City of Portland, Maine - Building or Use Permit Application 389 Congress Street, 04101, Tel: (207) 874-8703, FAX: 874-8716

BUILDING PERMIT REPORT

REASON FOR PERMIT: To Construct 24'x24' detached garage

Date:	09/03/98 @ 3:00 pm
To:	SAM HOFFSES
Company:	City of Portland
From:	Tim Cormier
Re:	303 SUMMIT STREET; ROSS CONVERSE BLG PERMIT APPL. --- REPLACEMENT CROSS SECTION ---
No. of Pages:	2 (which includes this cover sheet)

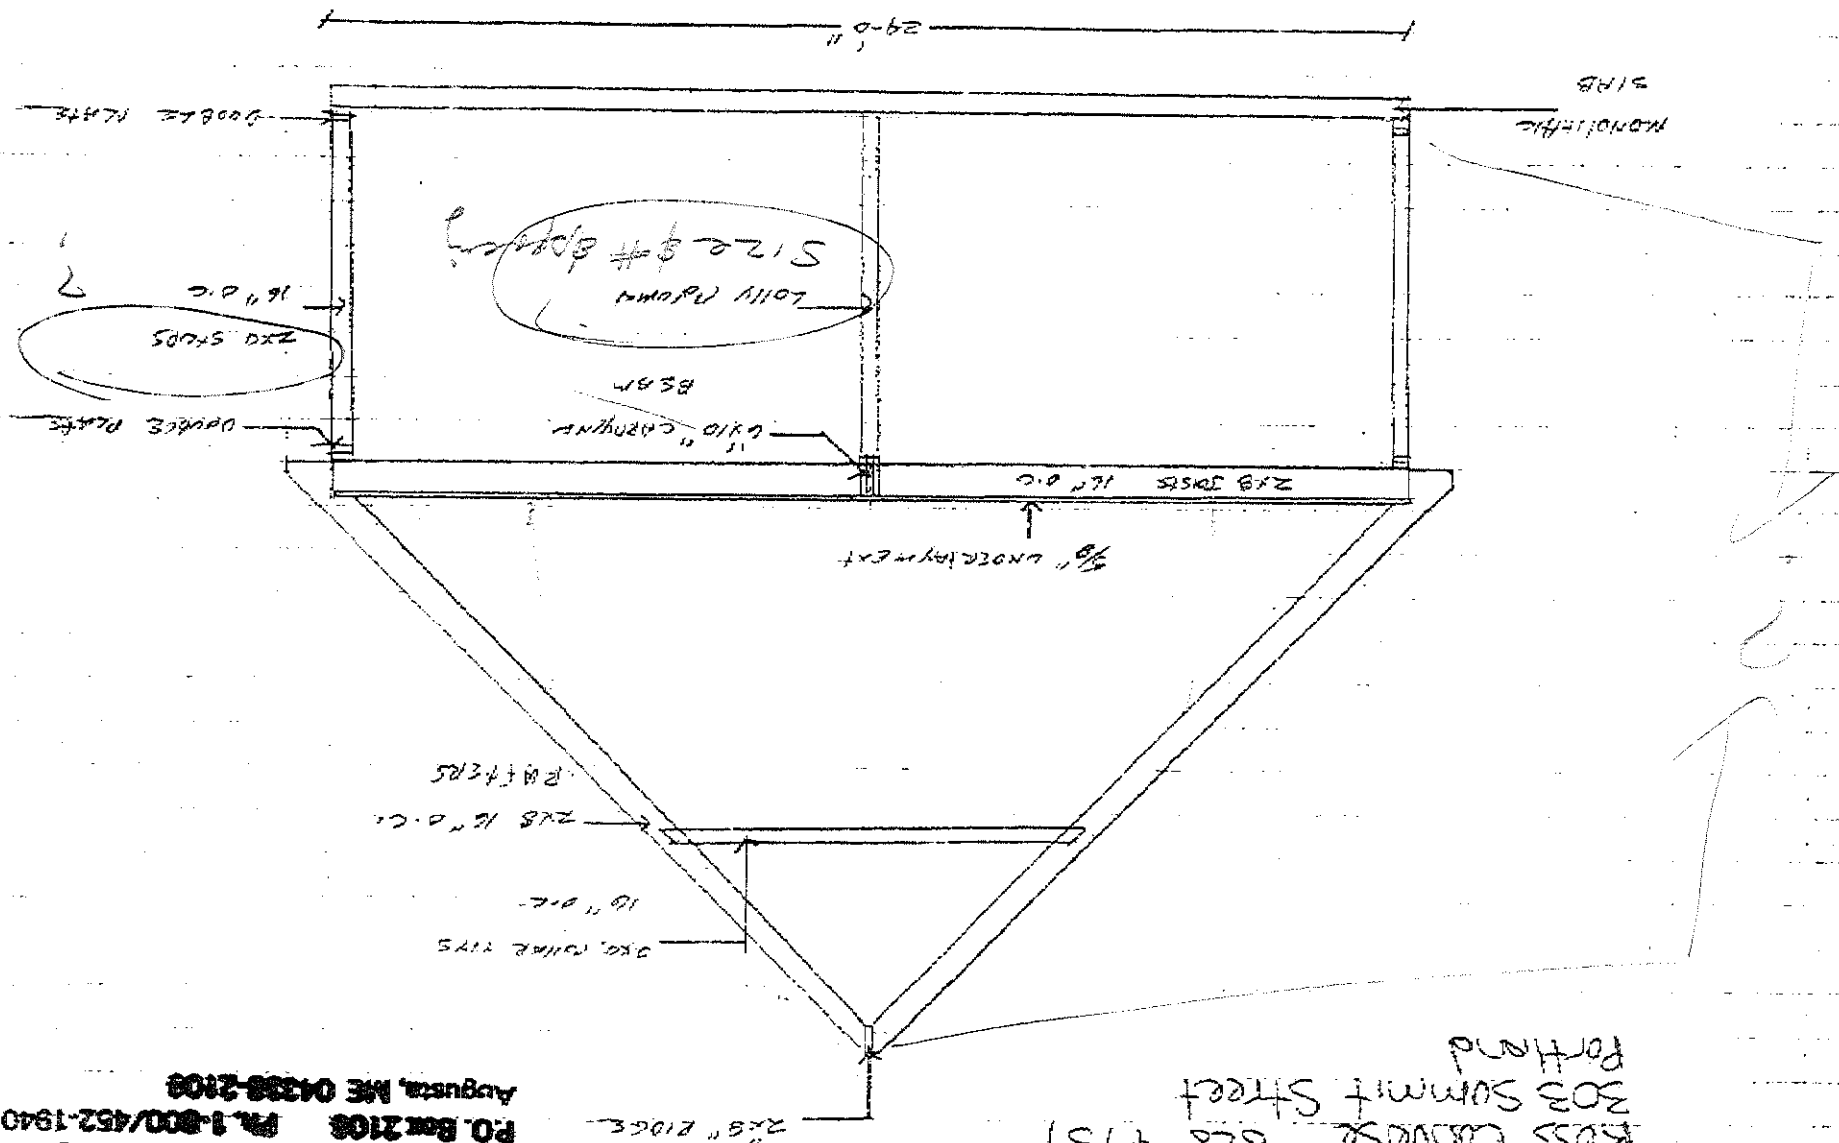
Mr. Hoffses - Please replace the original cross section that was submitted with the building permit application as it was sent in error.

The garage for Mr. Converse is a two-story building & the original cross section was for a one-story building.

CROSS SECTION

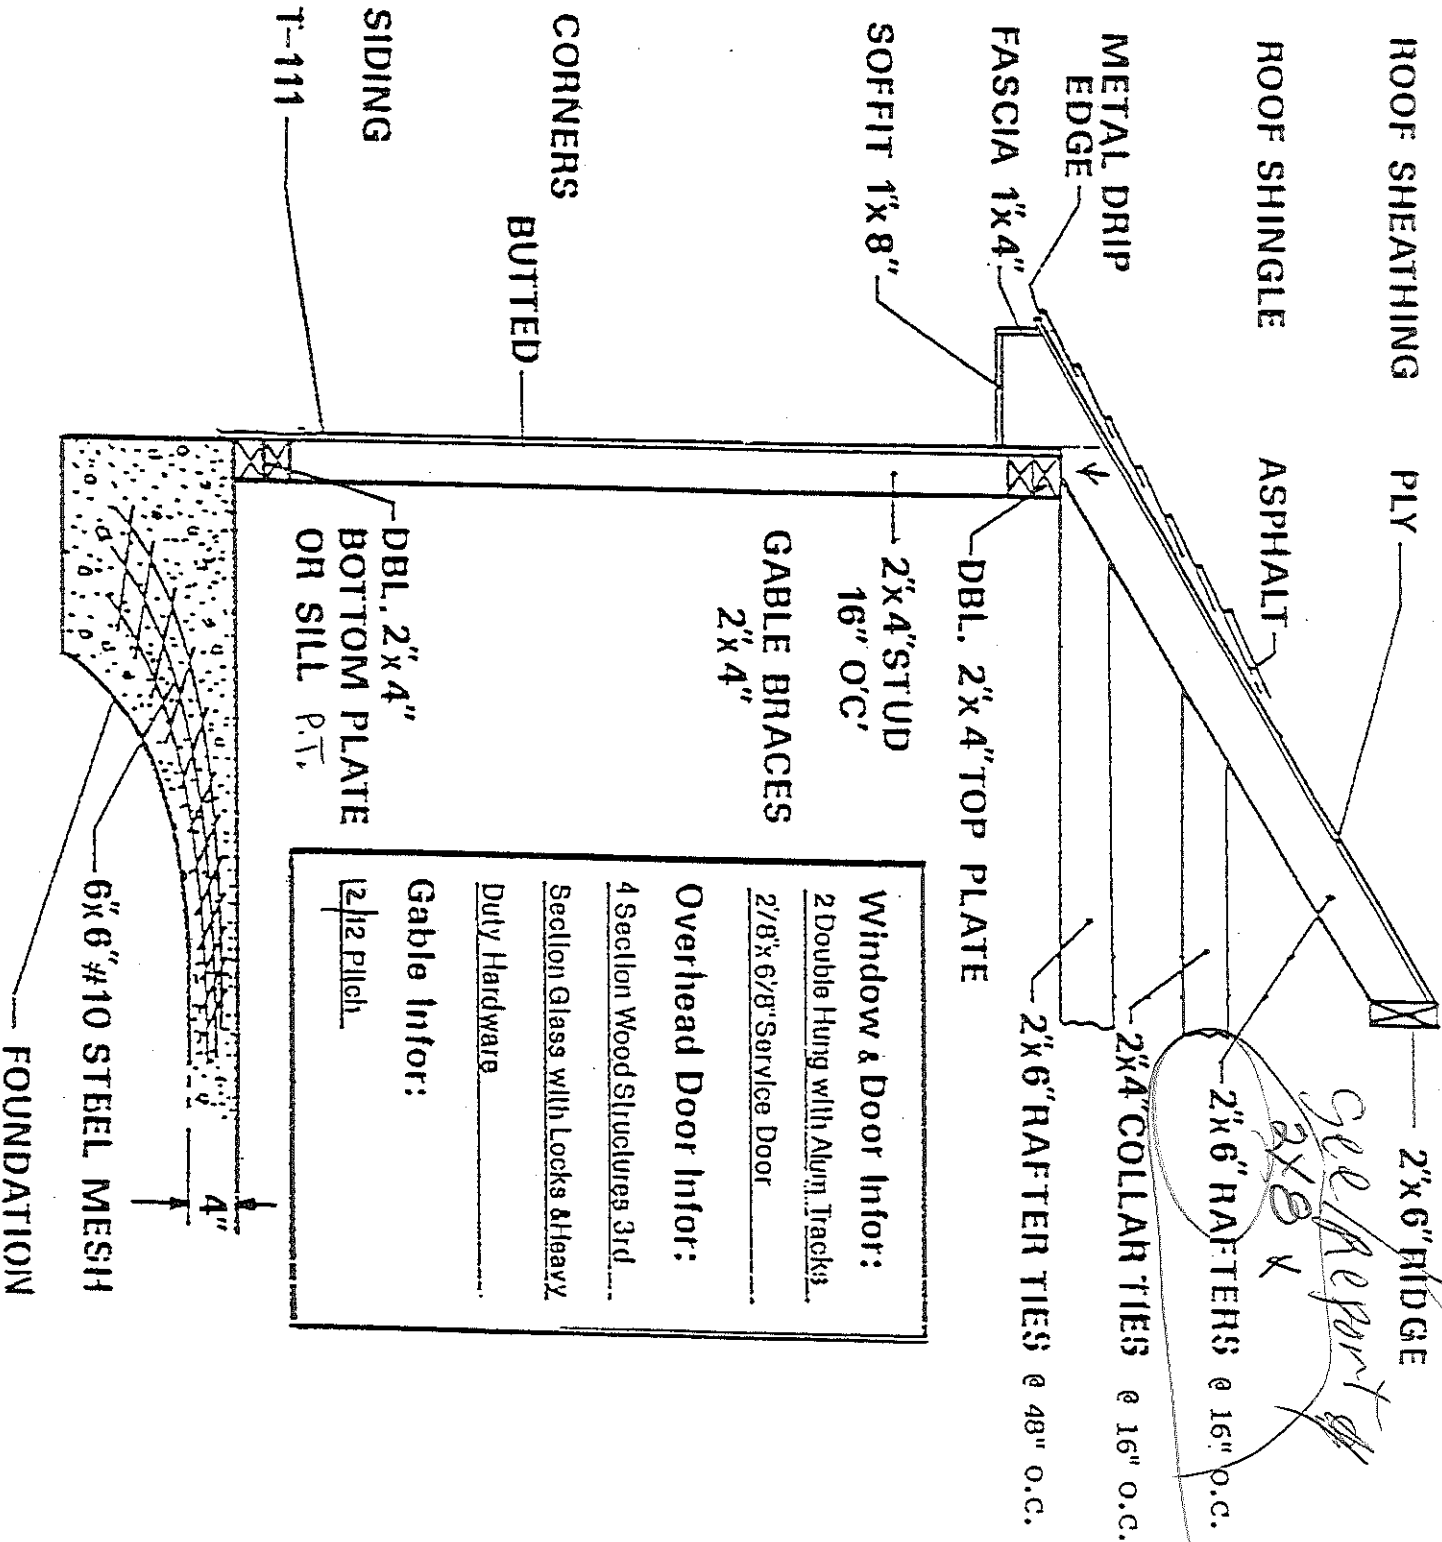
28. Please read and implement the attached Land Use-Zoning report requirements.
29. *The proposed 24x64 rafter @ 16" O.C. Spacing 12' + 1' will NOT*
30. *meet the building code requirements - A minimum of 2x8's will be required - Please amend your permit application to reflect your change before work begins*

2x8'S 16.0.C
- 2ND FL. FLOORING
- 3-2X10'S
- 7x12
STAIRS W/ 10" NET
36" RANDOM
7/4" RISE
